Re: **Case No. 08-170-EL-BTX**  
**OSU-Roberts 138kV Transmission Line Project**  
**Staff Questions/Clarifications Set#3**

**Roberts-OSU 138kV Transmission Project  
OPSB Case No. 08-0170-EL-BTX**

ATTACHMENT #4

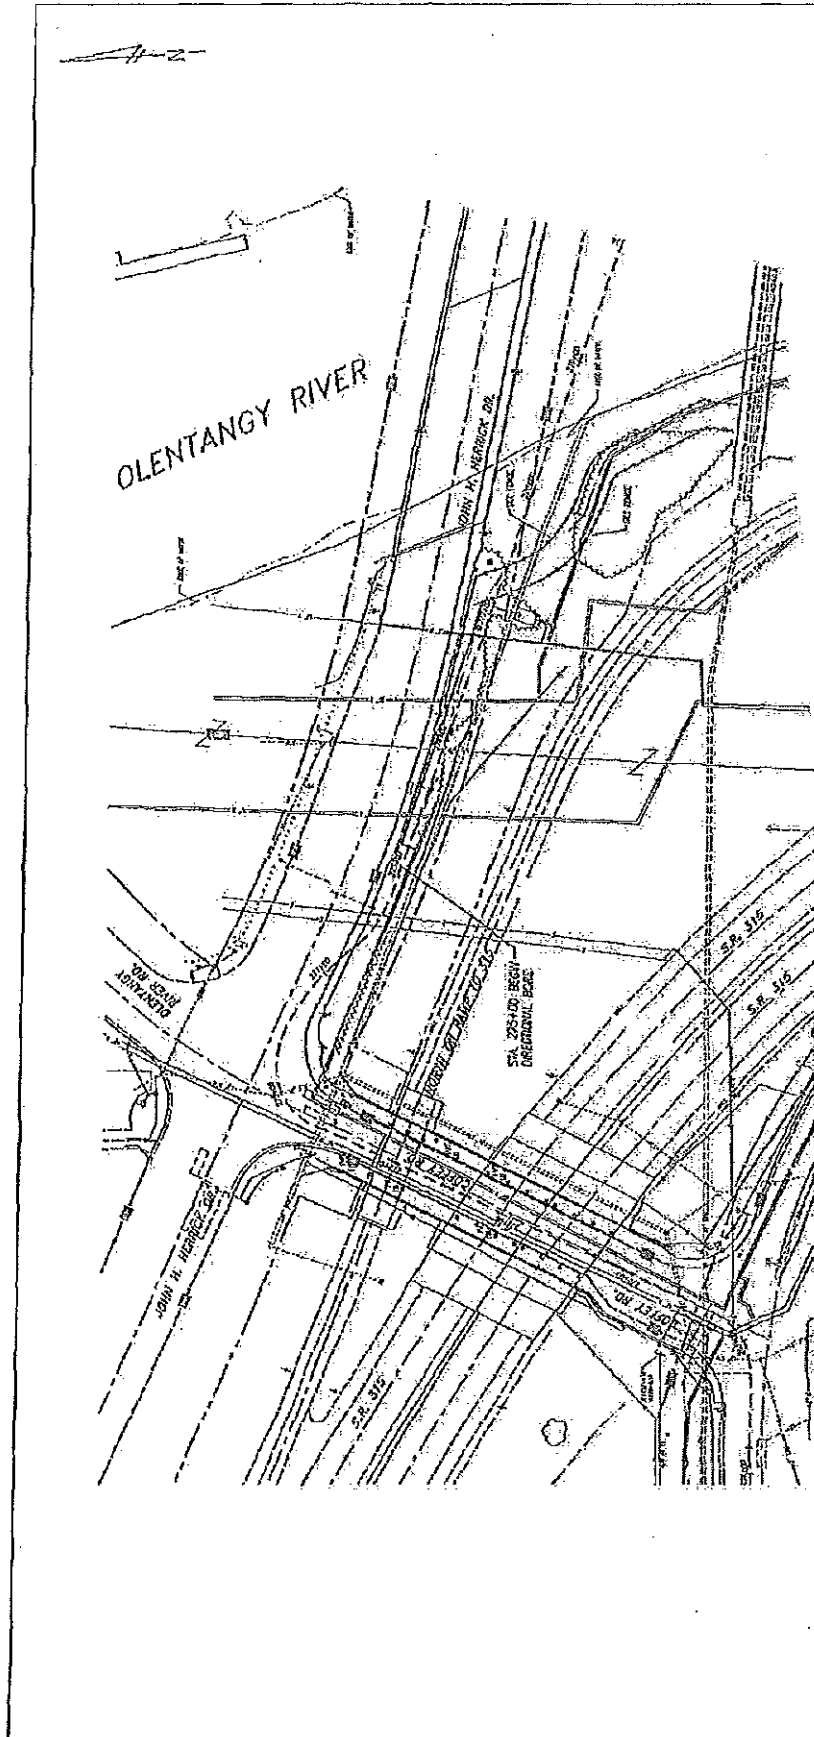
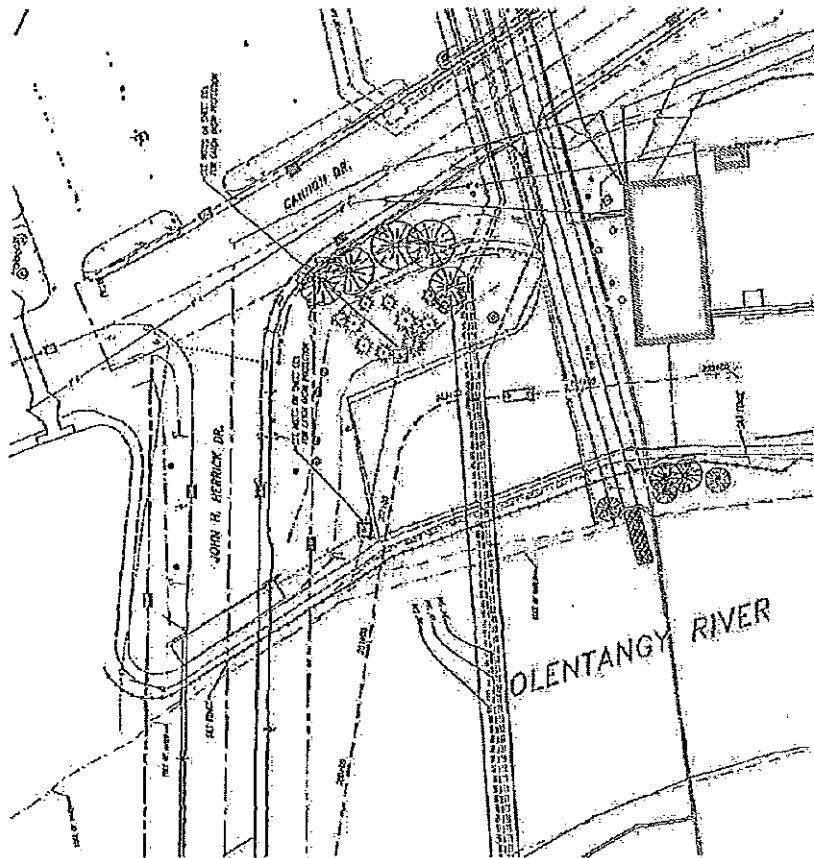
5. *Has the applicant developed a frac-out contingency plan for the two river crossings?*

**Drilling parameters for each river crossing are being engineered to maximize drilling fluid circulation and minimize risk of inadvertent return. However, the possibility of lost circulation cannot be completely eliminated. Therefore a frac-out contingency plan is being developed for the two river crossings. A**

preliminary plan is included as Attachment #4. A fully developed, project specific, frac-out contingency plan will be prepared after the Pipeline contractor and Directional Drilling contractor have been selected. This final frac-out contingency plan will be available to OPSB staff during pre-construction meeting.
